CITY OF ALBUQUERQUE

RE: **Lot 7 Block 5 Volcano Cliffs Unit 19 SAD 228
6531 Azor Pl. NW
Grading and Drainage Plan
Engineers Stamp Date 2/11/2021 (D10D003H7)
Pad Certification Date 3/23/2021**

Based upon the information provided in your submittal received 3/3/2021, this plan is approved for Building Permit.

DAVID SOULE P.E. #14522	6531 AZOR GRADING AND DRAINAGE PLAN	DRAWN BY WCVJ DATE 1-26-21 210210015-LAYOUT-2-10-21
	 Rio Grande Engineering 1606 CENTRAL AVENUE SE SUITE 201 ALBUQUERQUE, NM 87106 (505) 872-0998	SHEET # --- JOB # 21021008

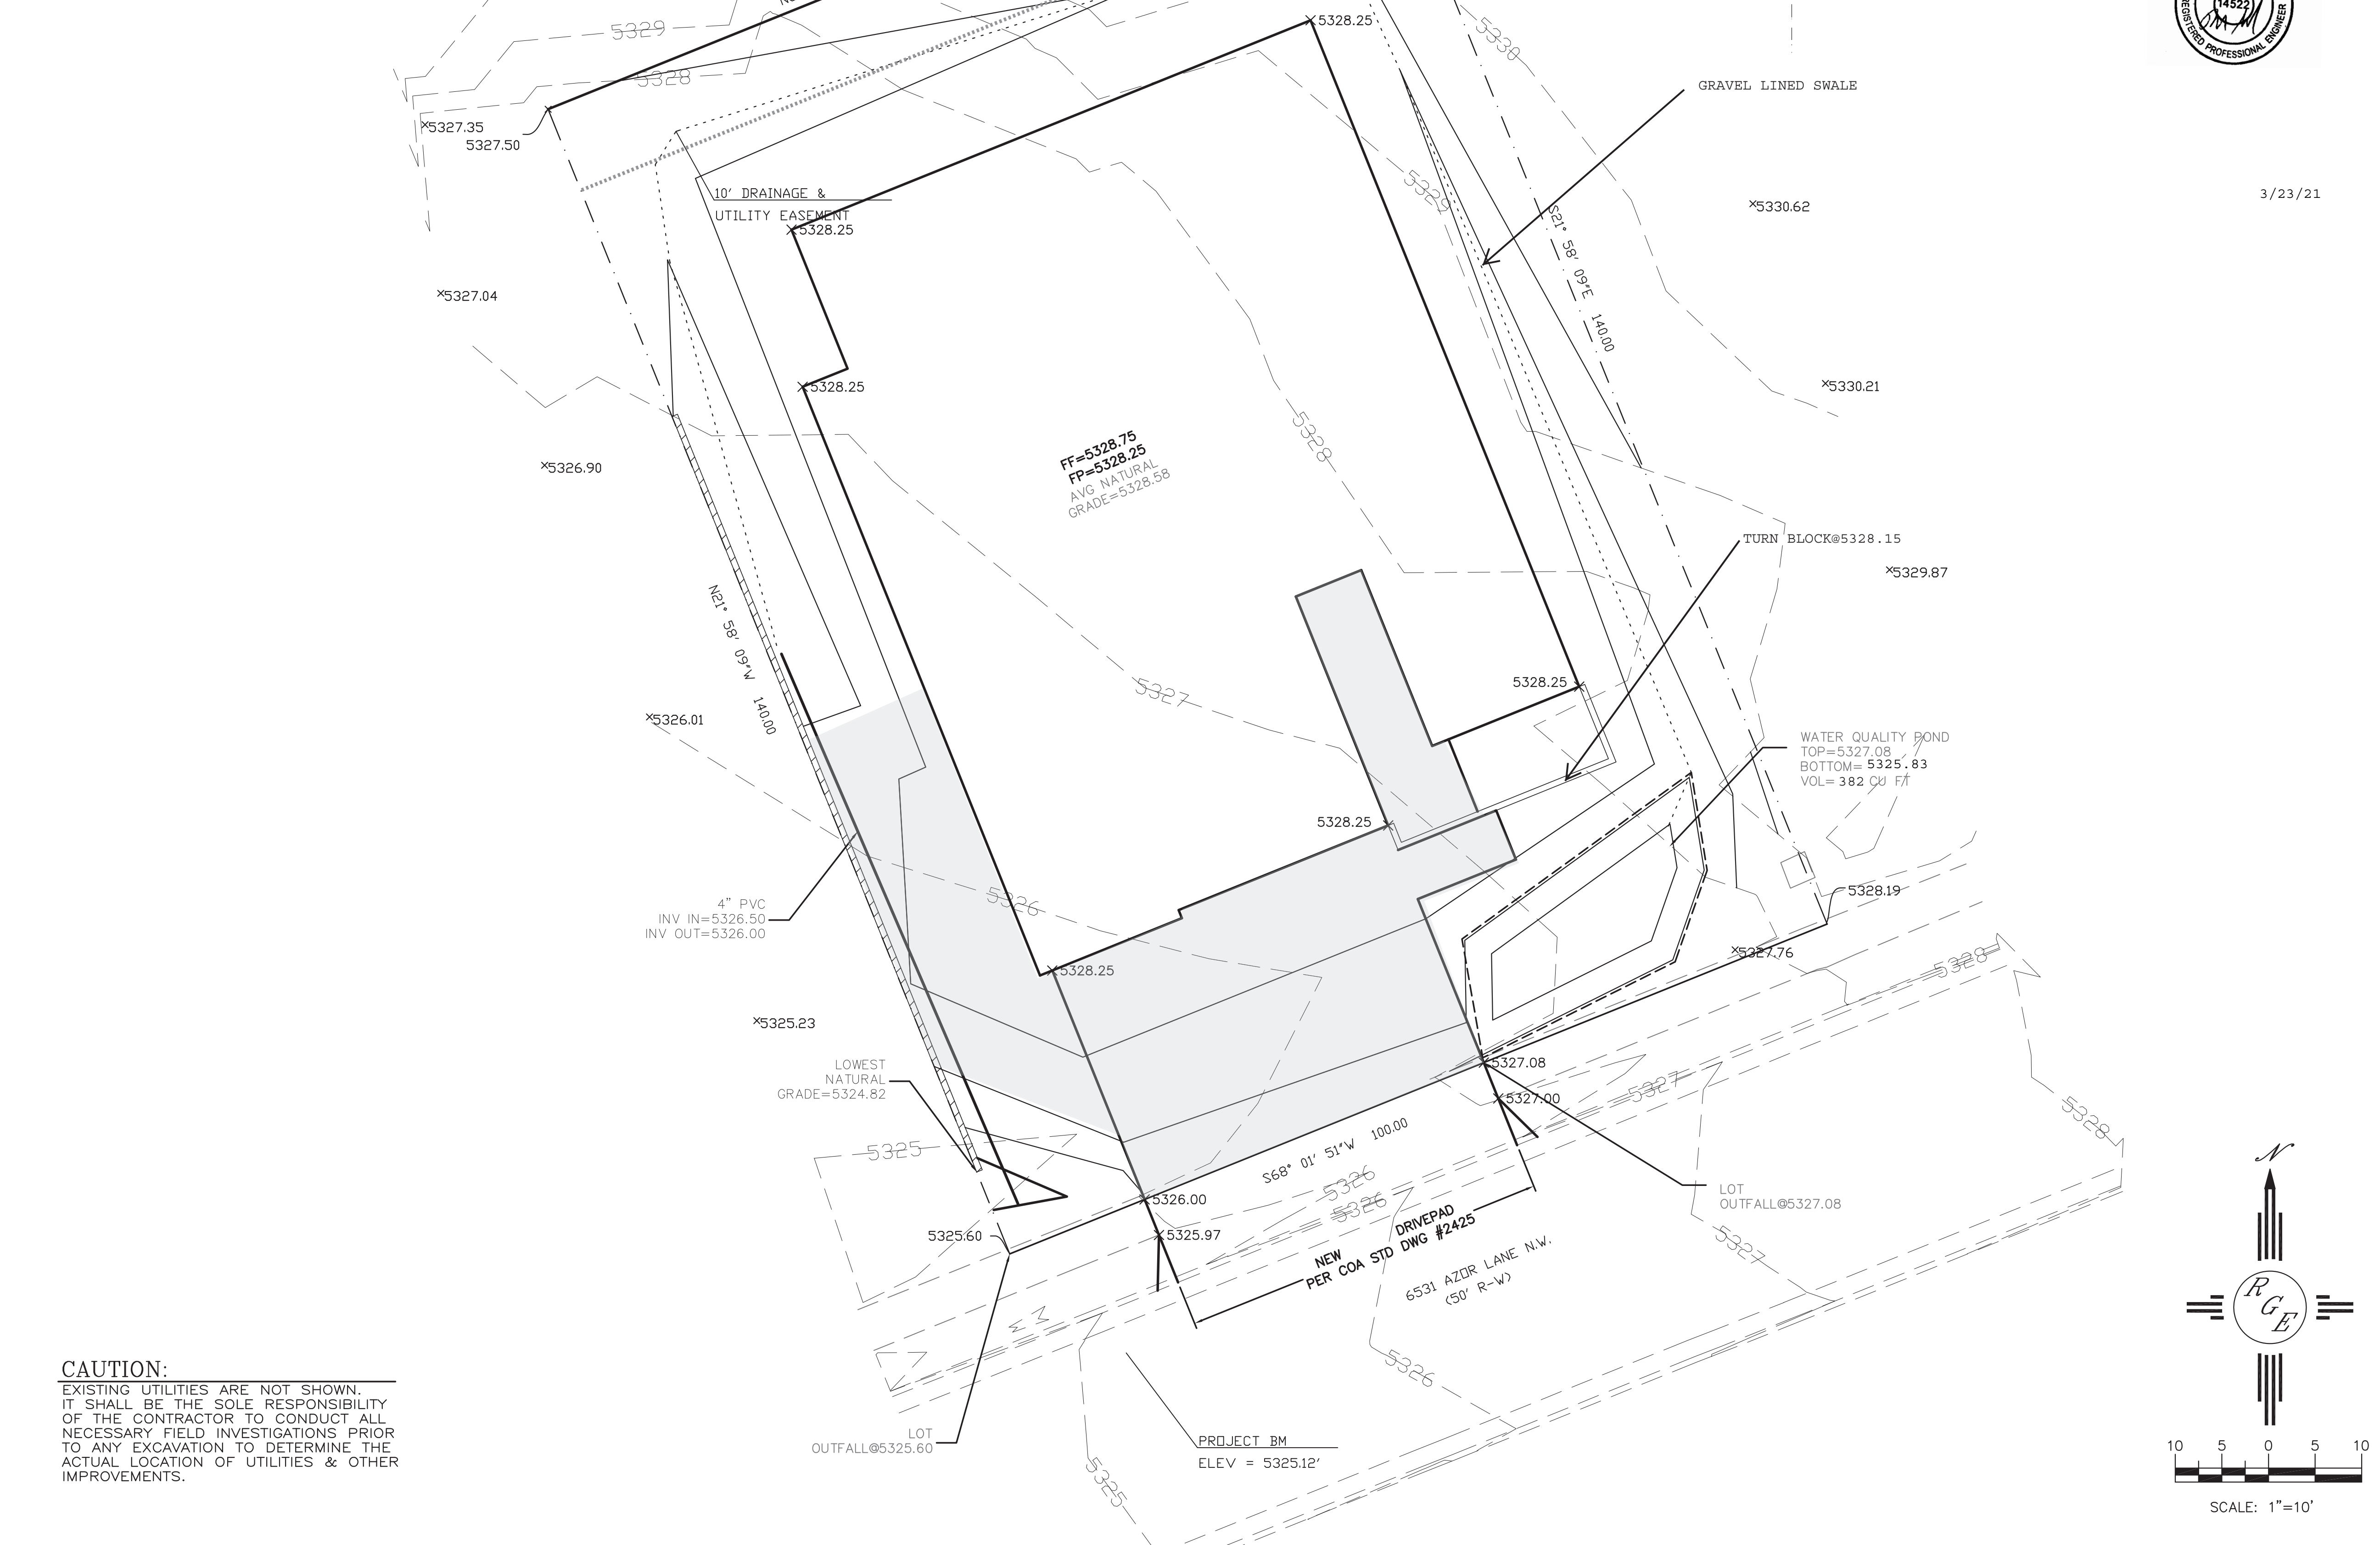
Please inform the builder/owner to attach a copy of this approved plan and this letter to the construction sets in the permitting process prior to sign-off by Hydrology.

Reiterate to the Owner/Contractor that a separate permit for a garden/retaining wall must be obtained, with the approved G&D plan and Pad Certification. Also, let the owner/contractor know that if a pool is to be added in the future the G&D plan will need to be modified showing the location of the pool and the land treatment differences.

Prior to Certificate of Occupancy release, Engineer Certification per the DPM checklist of this plan will be required.
